**TITLE: FUEL - INTRODUCTION OF IMPROVED FUEL CELL GASKET**

This Service Bulletin is being issued to install a more moisture-resistant gasket for use on the fuel cell covers.

This Service Bulletin announces a fluorosilicone rubber gasket, P/N 50-921587-9, which replaces gasket P/N 50-921587-7.

**Fuel Cell Gaskets  
Figure 1**

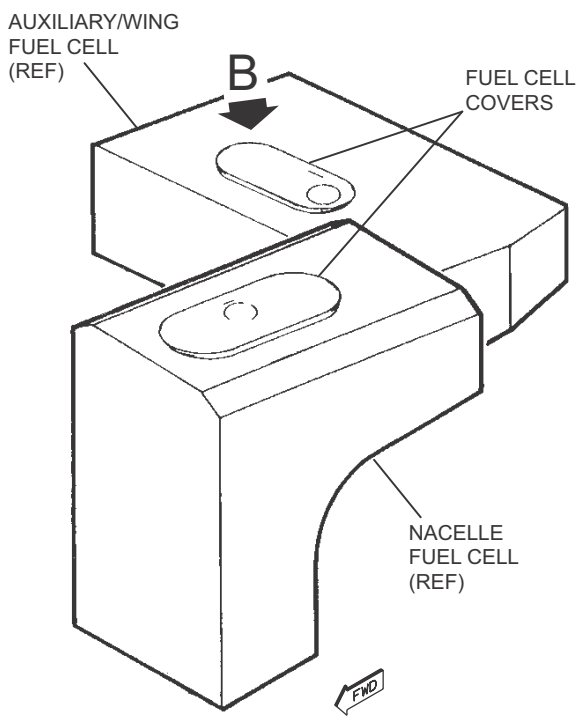
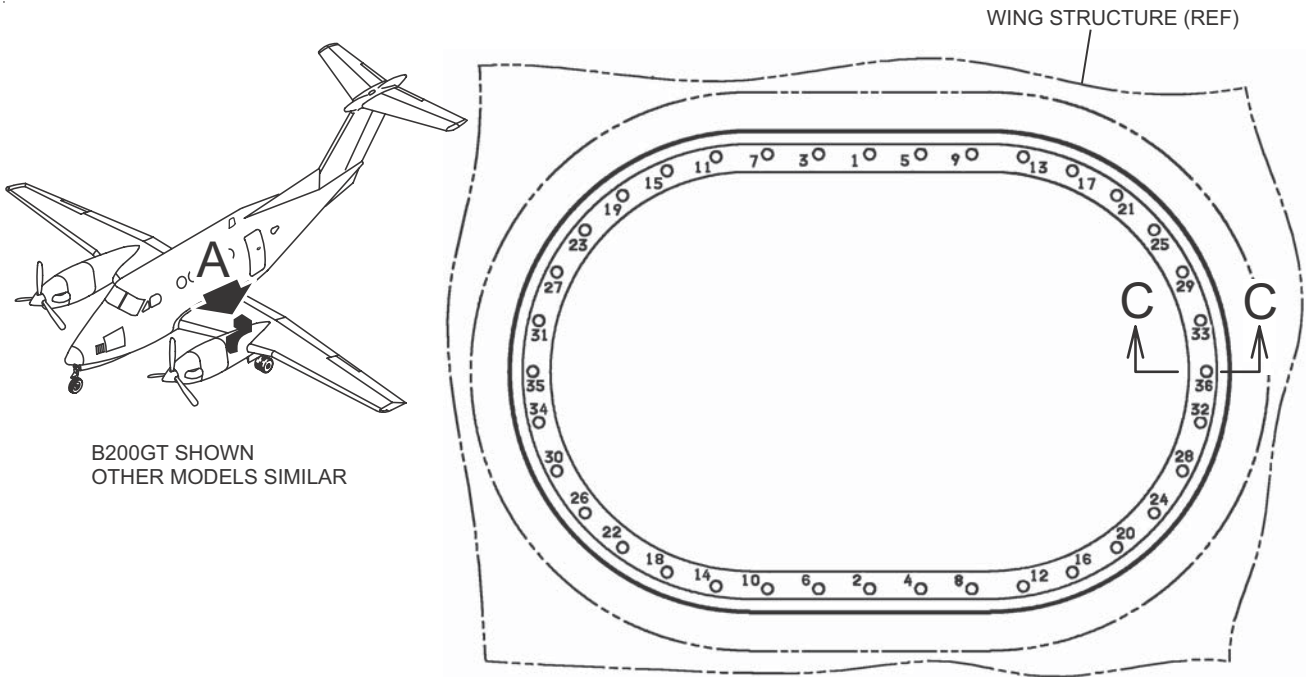
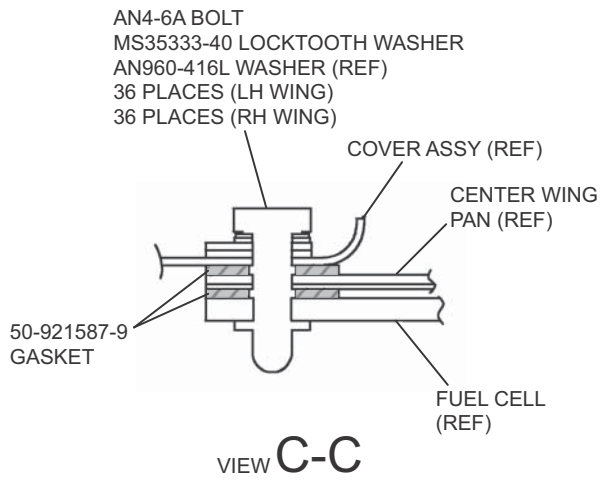
- (10) Install new P/N 50-921587-9 gaskets; two (2) per nacelle. Refer to Figure 1, View C-C for proper placement.
- (11) Install cover assembly with retained bolts:
  - (a) Ensure all holes are aligned with fuel liner nuts prior to insertion of bolts.

It is important to tighten access panels in a definite pattern to ensure uniform compression of seals and prevent possible fuel seepage. When securing the panel, initially snug the screws in the defined sequence, then tighten the screws in the same sequence. Refer to Figure 1, Detail B.

- (21) Install new P/N 50-921587-9 gaskets; two (2) per fuel cell. Refer to Figure 1, View C-C for proper placement.

It is important to tighten access panels in a definite pattern to ensure uniform compression of seals and prevent possible fuel seepage. When securing the panel, initially snug the screws in the defined sequence, then tighten the screws in the same sequence. Refer to Figure 1, Detail B.

- (b) Install bolts, new P/N MS35333-40 locktooth washers, and retained P/N AN960-416L flat washers (flat washer against cover).
- (c) Torque bolts to 35 to 40 inch-pounds in the sequence shown.
- (d) Check torque in sequence shown and re-torque bolt **only** if torque is lower than 30 inch-pounds.
- (12) Install plumbing and electrical wiring removed in Step (6) to access fuel cell. Refer to applicable MM, Chapter 28-40-00.
- (13) Repeat fuel cell gasket replacement procedure on opposite nacelle fuel cell.
- (14) If airplane is equipped with auxiliary or center wing fuel cells, proceed to Step (15). If not, proceed to Step (25).

- (b) Install bolts, new P/N MS35333-40 locktooth washers, and retained P/N AN960-416L flat washers (flat washer against cover).
- (c) Torque bolts to 35 to 40 inch-pounds in the sequence shown.

- (d) Check torque in sequence shown and re-torque bolt **only** if torque is lower than 30 inch-pounds.
- (23) Install plumbing and electrical wiring removed in Step (17) to access fuel cell. Refer to applicable MM, Chapter 28-40-00.
